# APPROVED MINUTES

## October 21, 2021 Standards Committee Meeting

RE: Minutes from the October 21, 2021 Standards Committee Meeting

PROPOSED SOLUTION: Revise and update the standard drawing series on flagger operations (E 801-TCFO) and create a new series for mobile operations (E 801-TCMO). Delete unnecessary and duplicate details from the temporary closure series (E 801-TCTC).

E 801-TCFO-02 FLAGGER OPERATION FOR MULTIPLE WORK AREAS WITH POSTED SPEED  $\geq$  50 MPH (PROPOSED DRAFT)

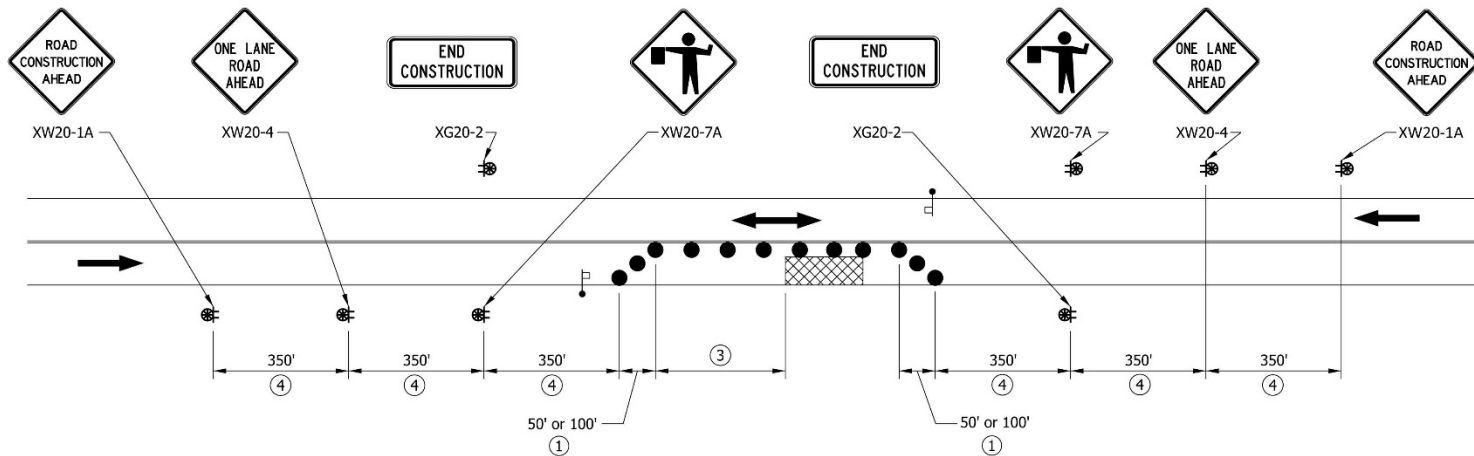
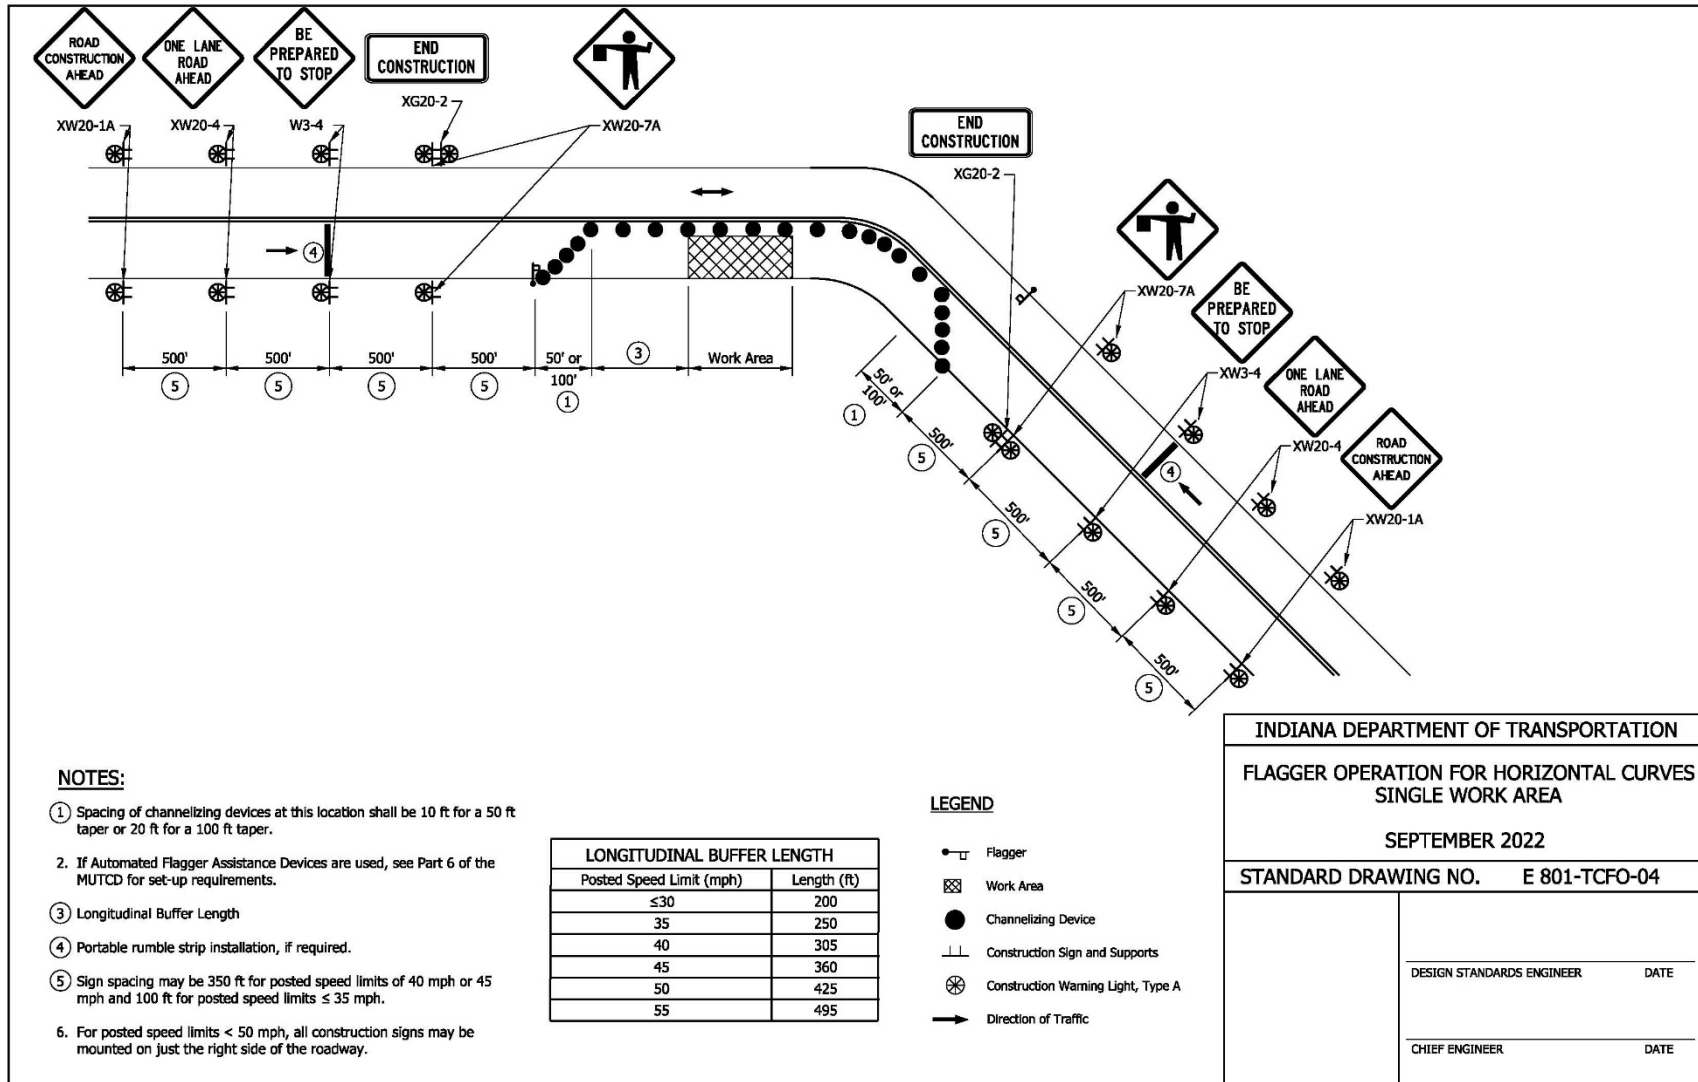
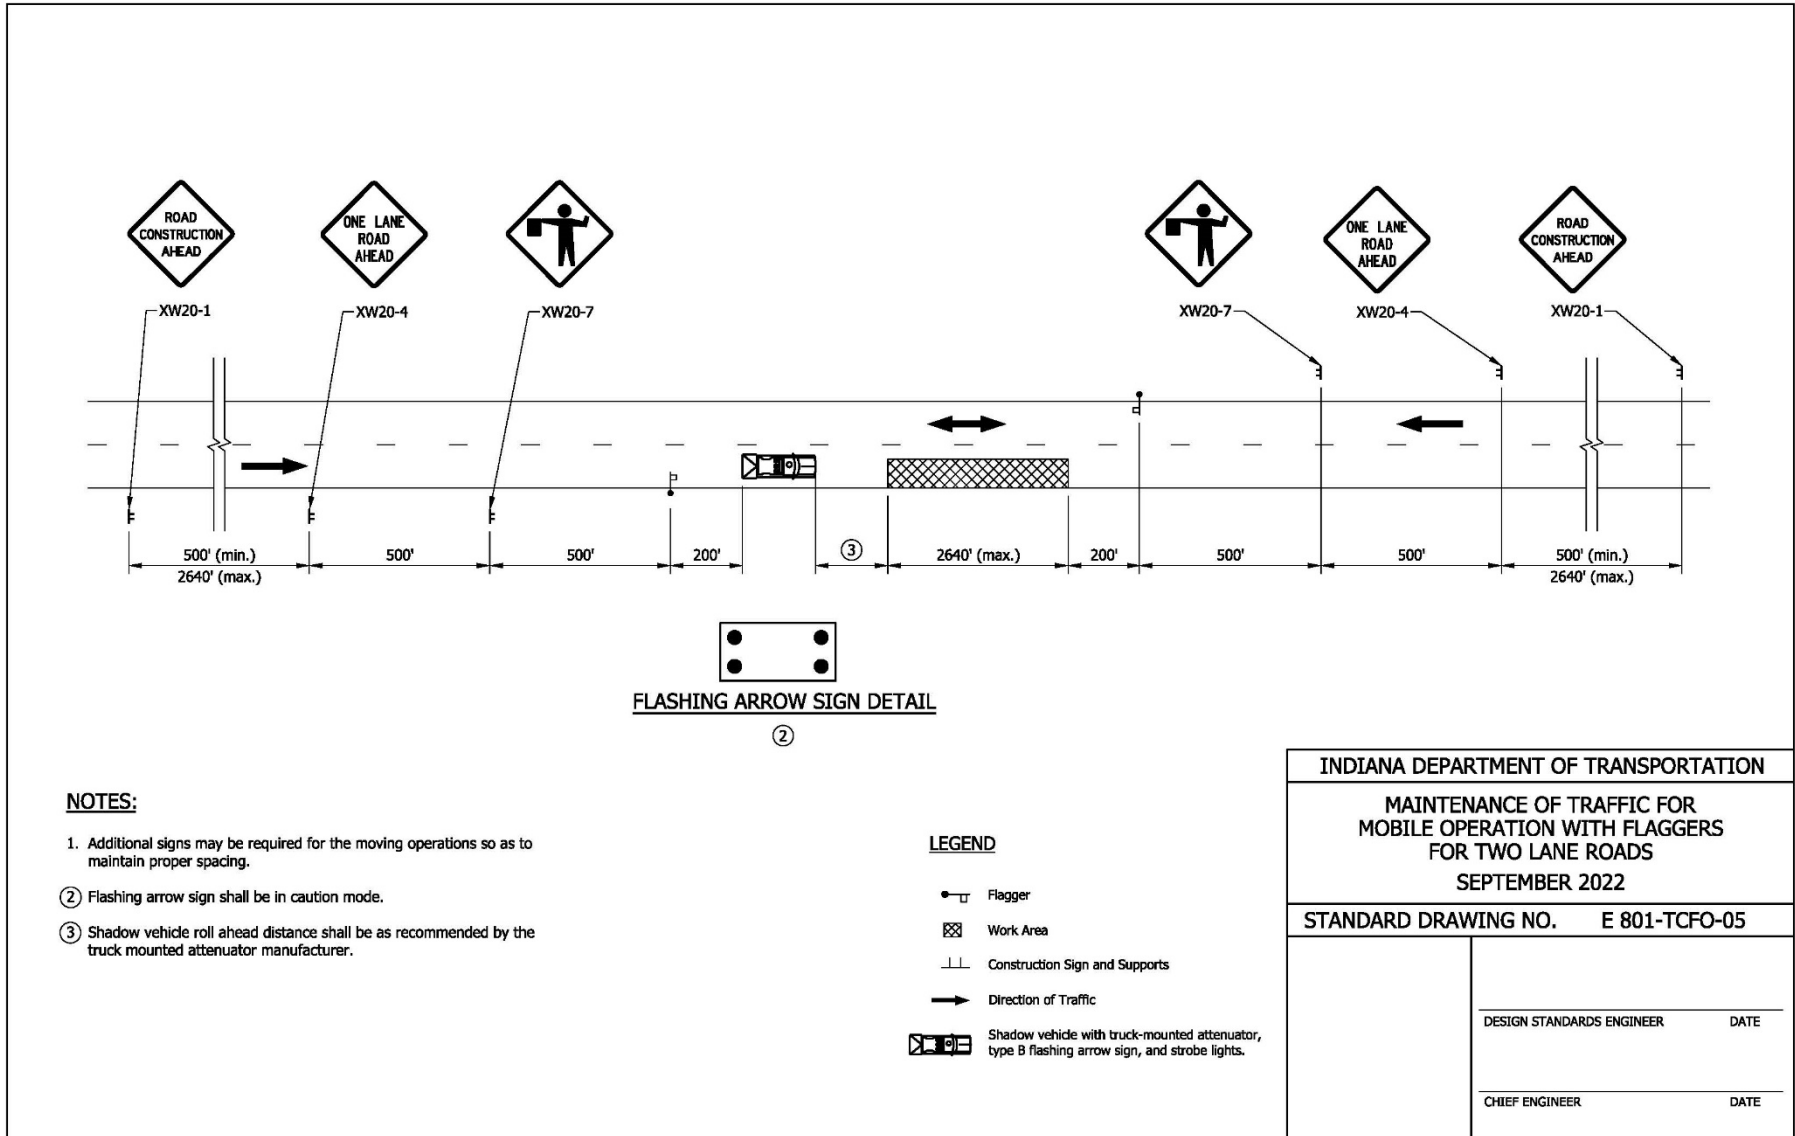
Mr. Koch asked if the taper rate shown in 801-TCFO-02, 3 & 4 is optional, and if further guidance is needed. Mr. Bruno responded that there is existing guidance on this as Figure 503-7D of the Design Manual recommends 100 ft as the two-way traffic taper. However, the two-traffic taper in IMUTCD Figure 6H-10 on flagging is 50 to 100 ft, which matches the current 801-TCFO series. As a result, an option for 50 ft two-way traffic tapers is being retained for situations such as where the shorter taper would keep a driveway out of the work zone or would allow the flaggers to be able to see each other. The potential circumstances where a 50 ft taper may be used could be added as a note to IDM Figure 503-7D.
